ADDENDUM

May 15, 2020

RFB NO. 320012 - ADDENDUM NO. 1

**DANE COUNTY JAIL CONSOLIDATION
COURTHOUSE ELECTRICAL VAULT RELOCATION**

1 ELECTRICAL VAULT FLOOR PLAN
SCALE: 1/8" = 1'-0"

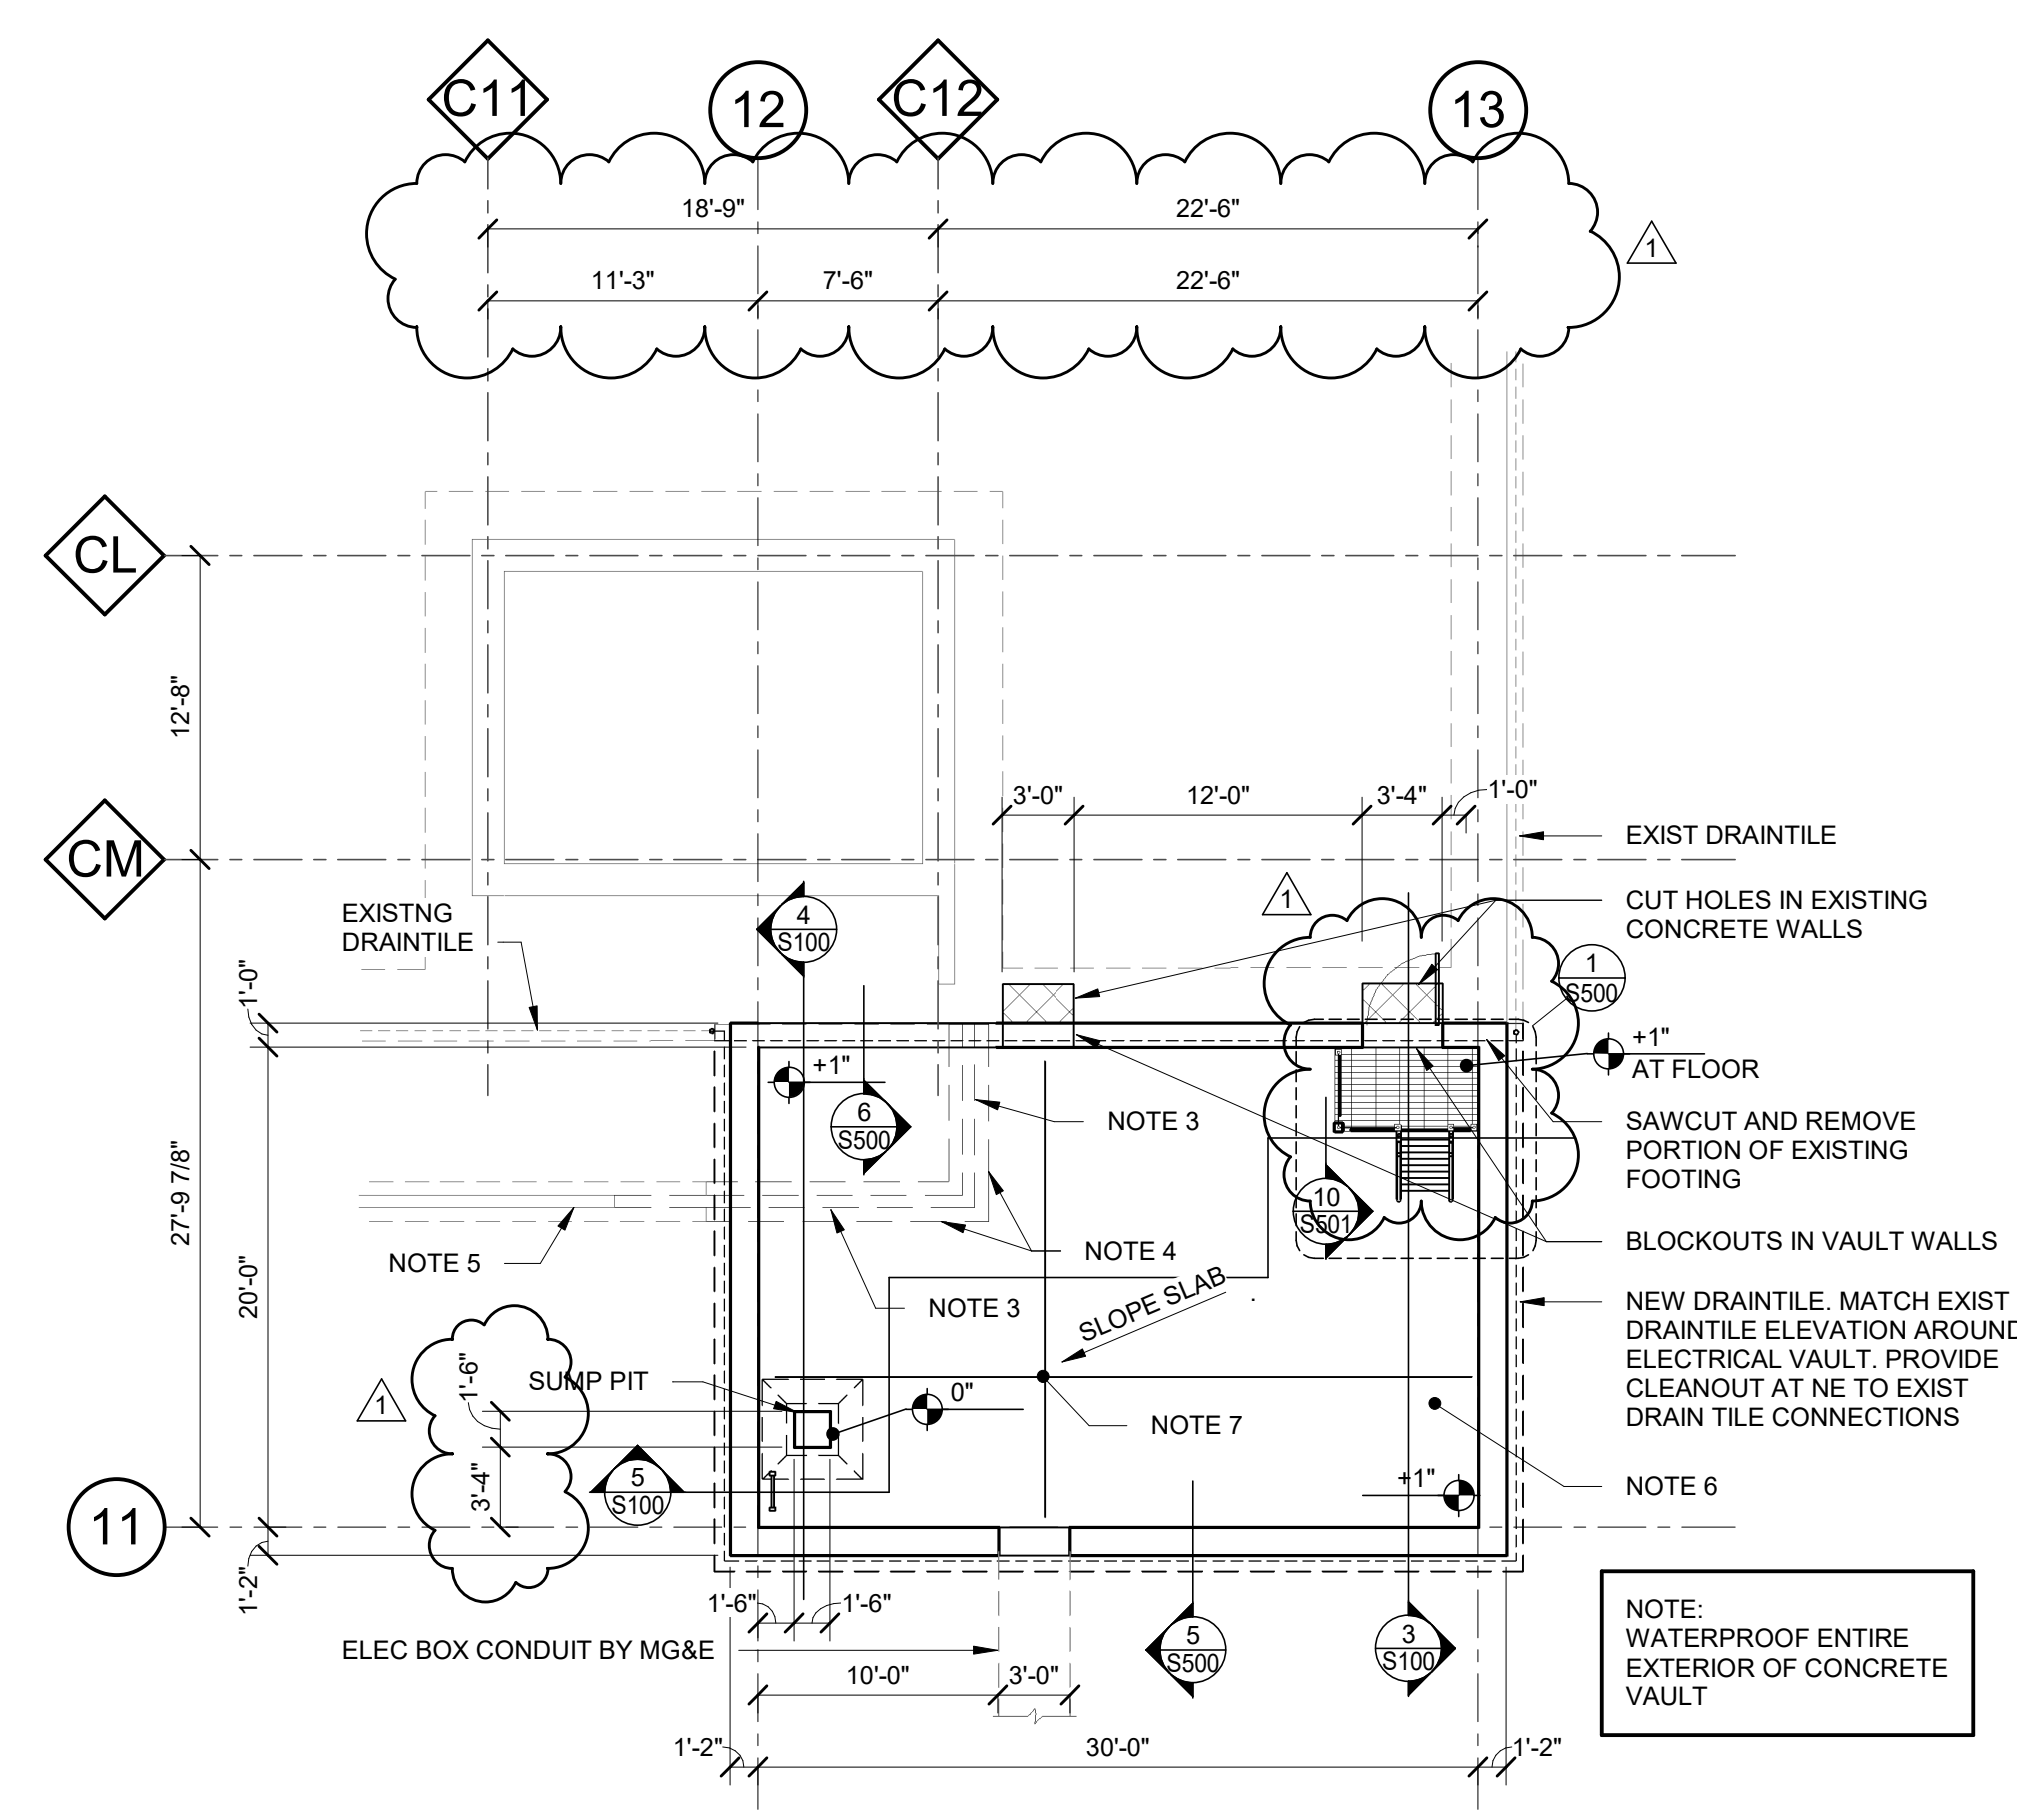
- a. Reference 1/S100 and note the revised dimensions, revised planter box wall layout, revised platform layout, and shift vault 2 inches to the southwest.

2 ELECTRICAL VAULT CEILING PLAN
SCALE: 1/8" = 1'-0"

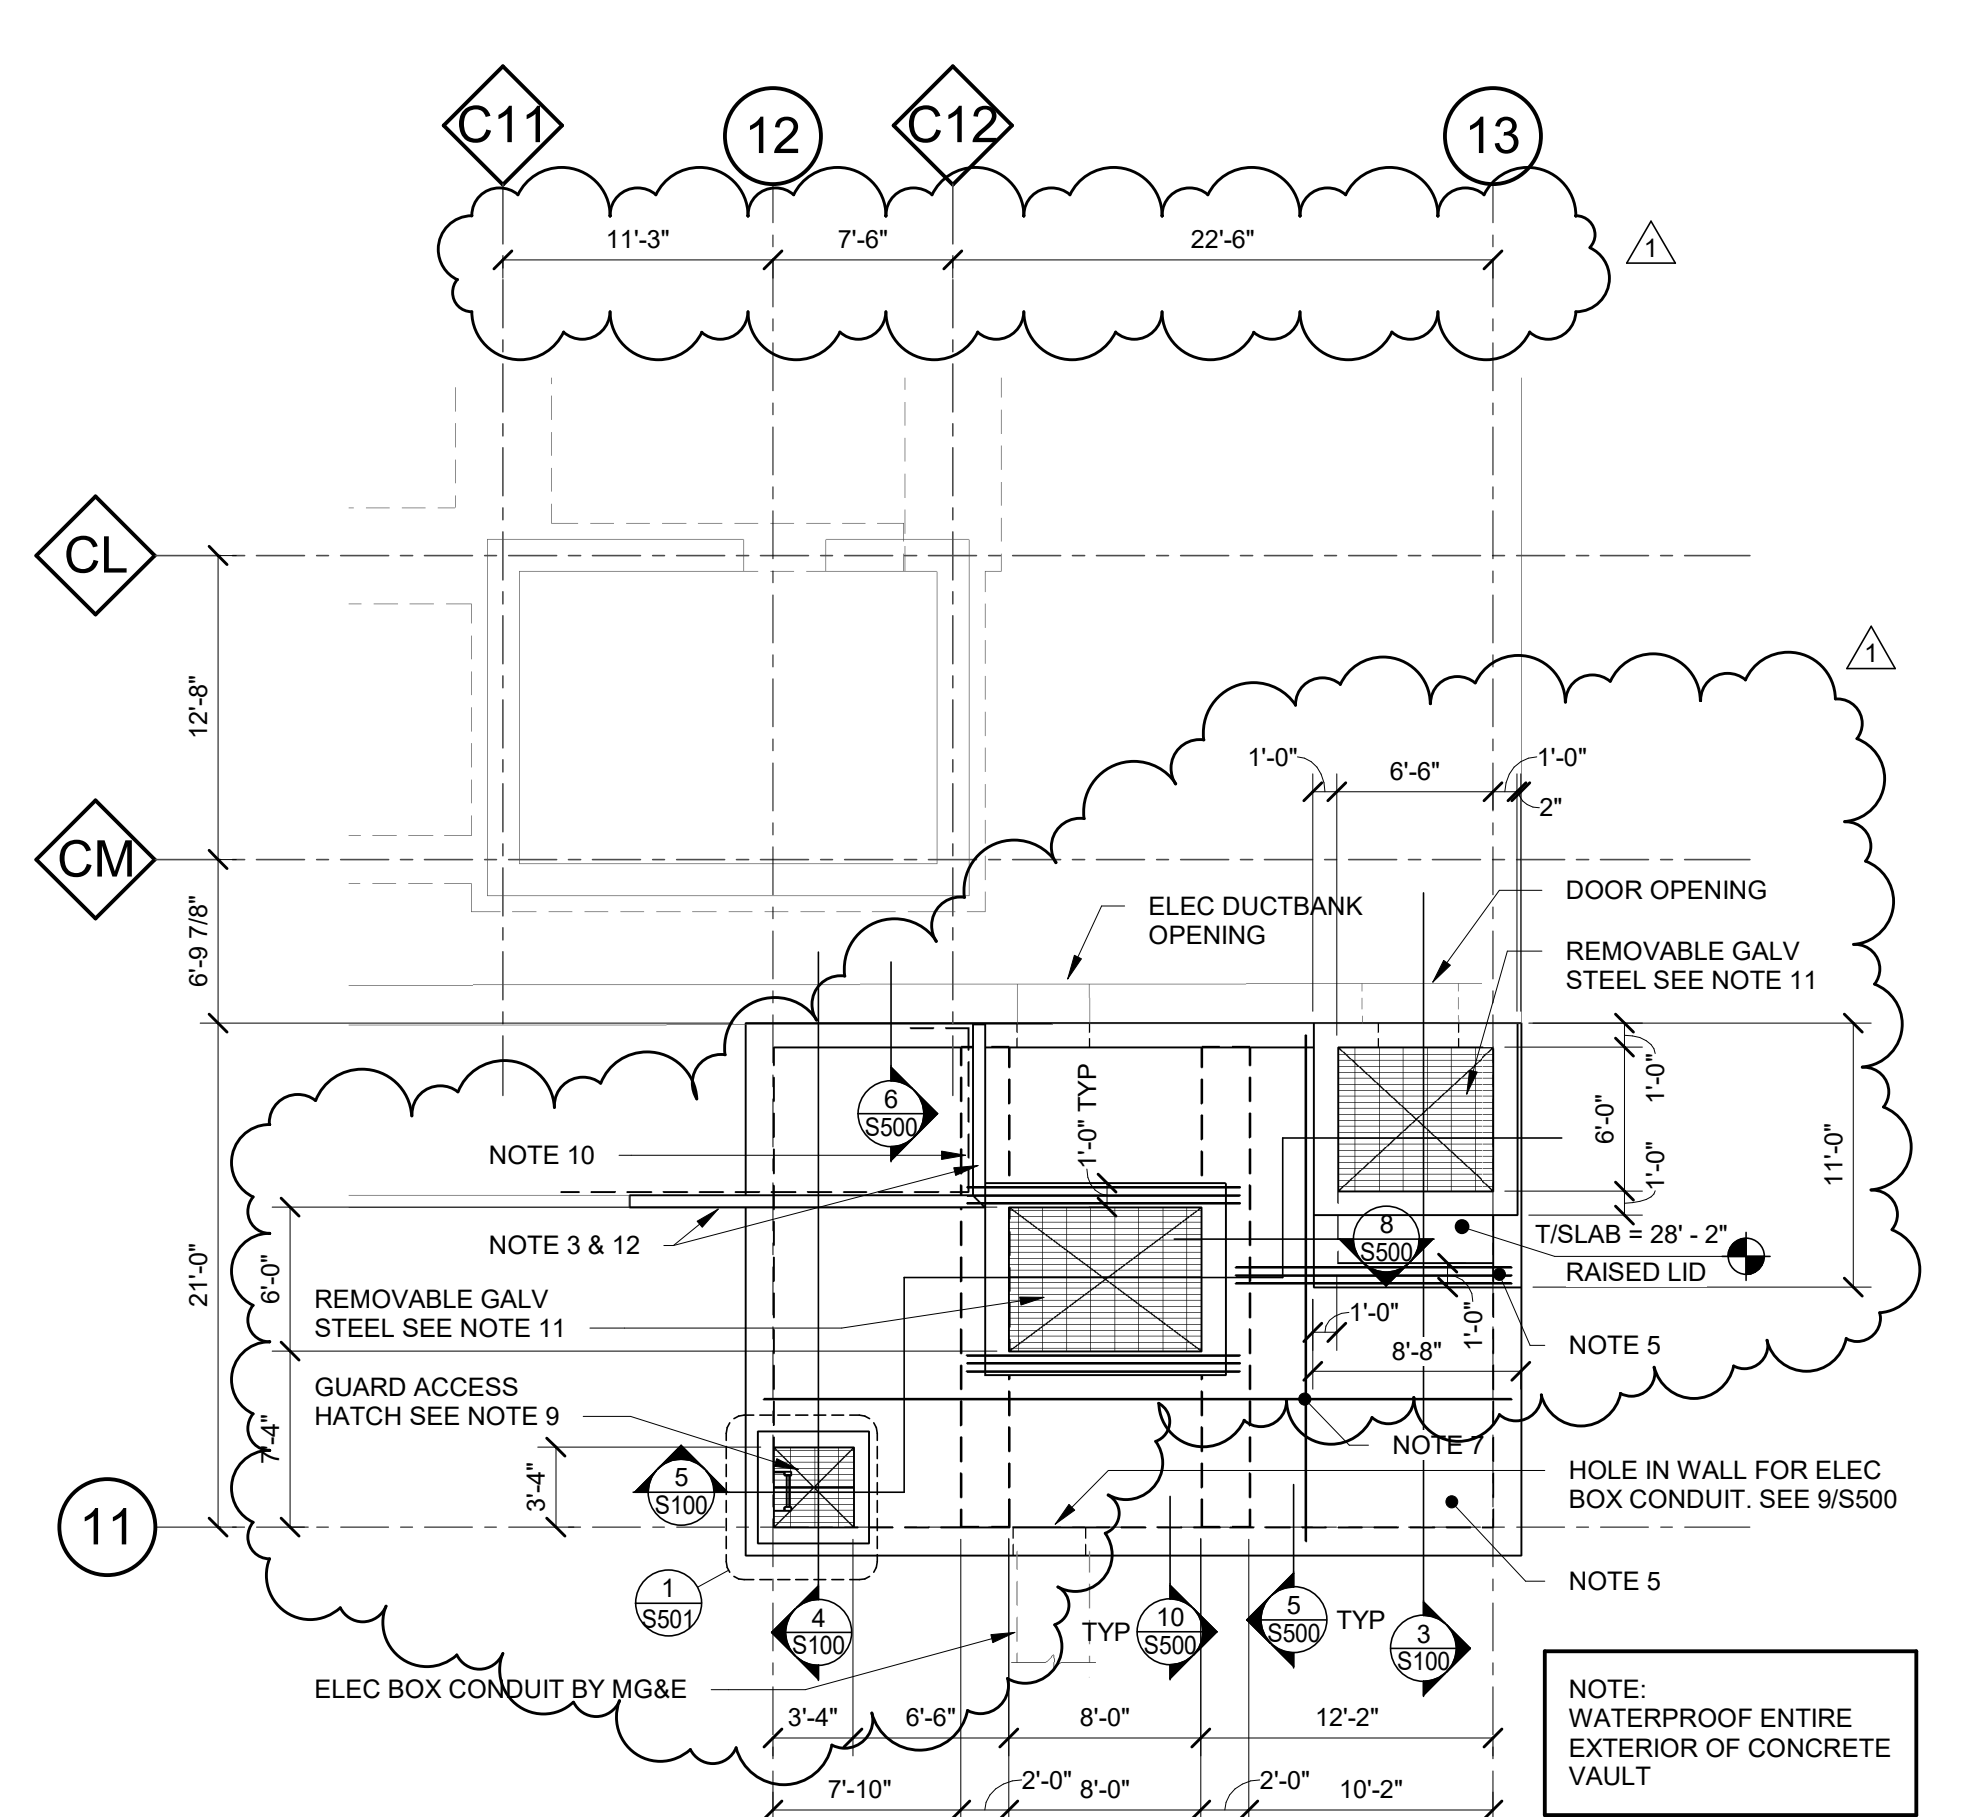
- b. Reference 2/S100 and note the revised dimensions, revised plant box wall layout with waterproofing, revised access hatch specification, revised equipment access lid framing change to grated steel, relocated and resized ventilation port with added grating, and the vault shift 2 inches to the southwest.

3 ELECTRICAL VAULT ELEVATION
SCALE: 1/4" = 1'-0"

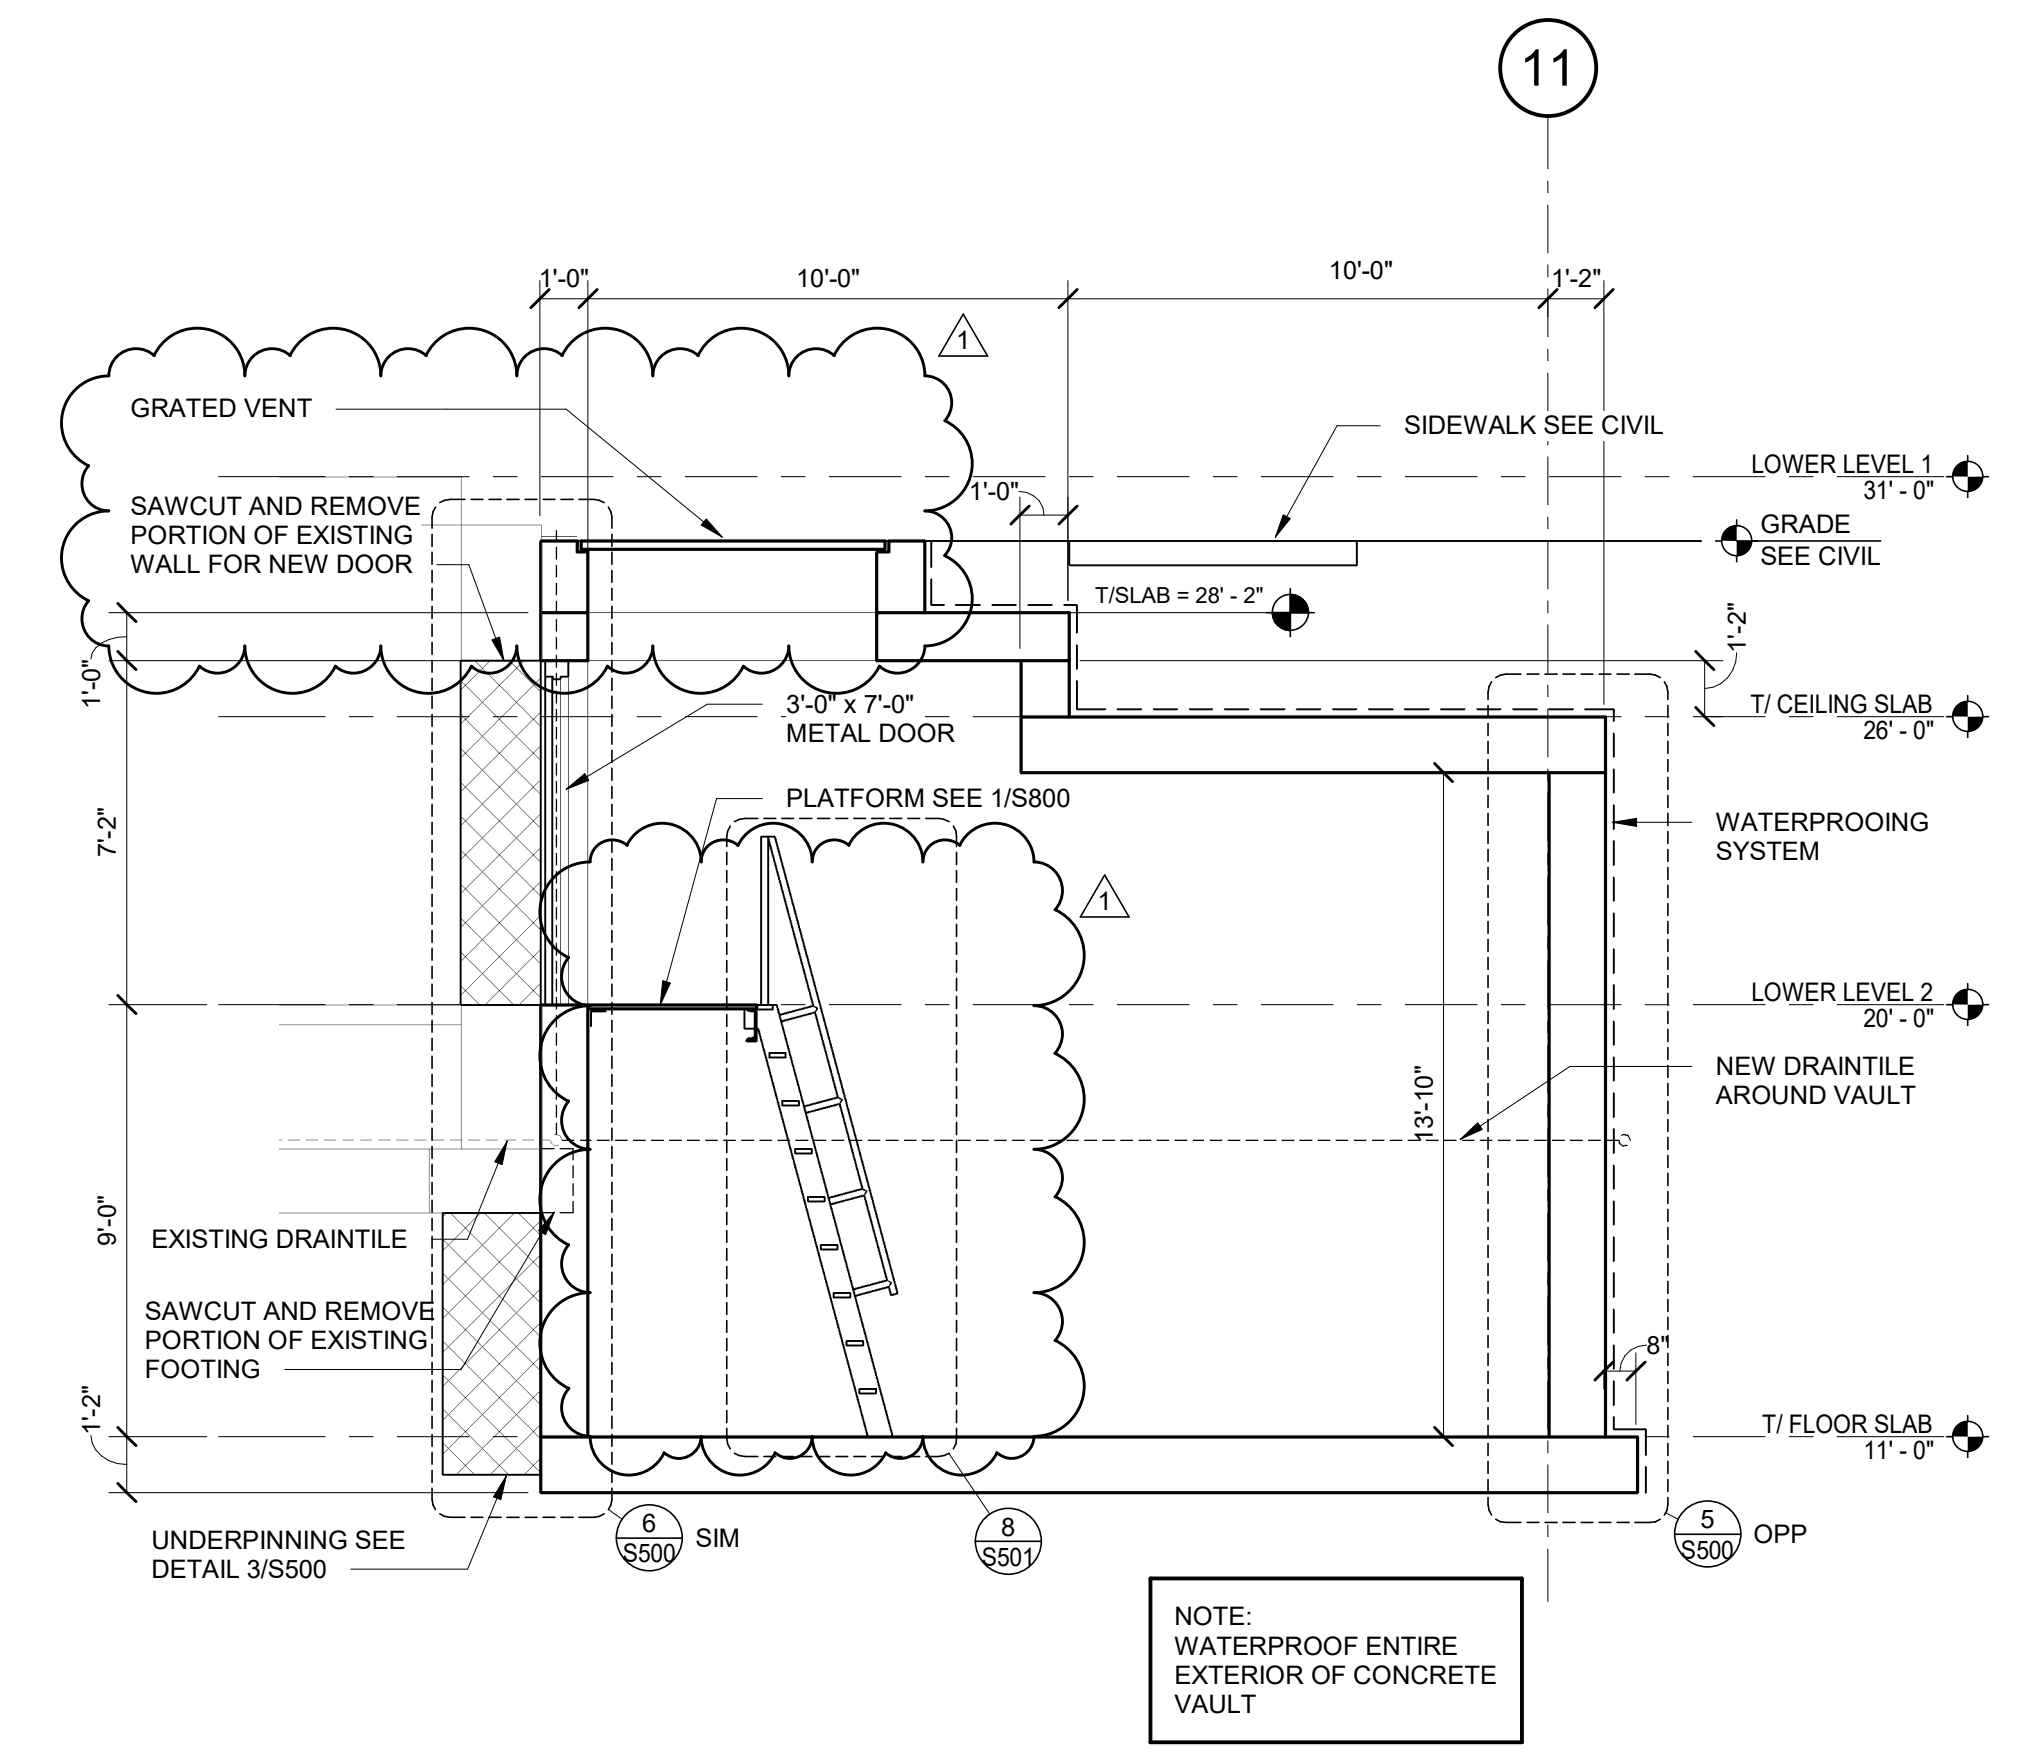
- c. Reference 3/S100 and note the added ventilation port with steel grating, and the dimensional change to the landing platform.
- d. Reference 4/S100 and note the removal of the planter box wall, removal of the ventilation port, and the addition of commentary regarding remediation of the existing foundation wall surface that is becoming exposed to public view.
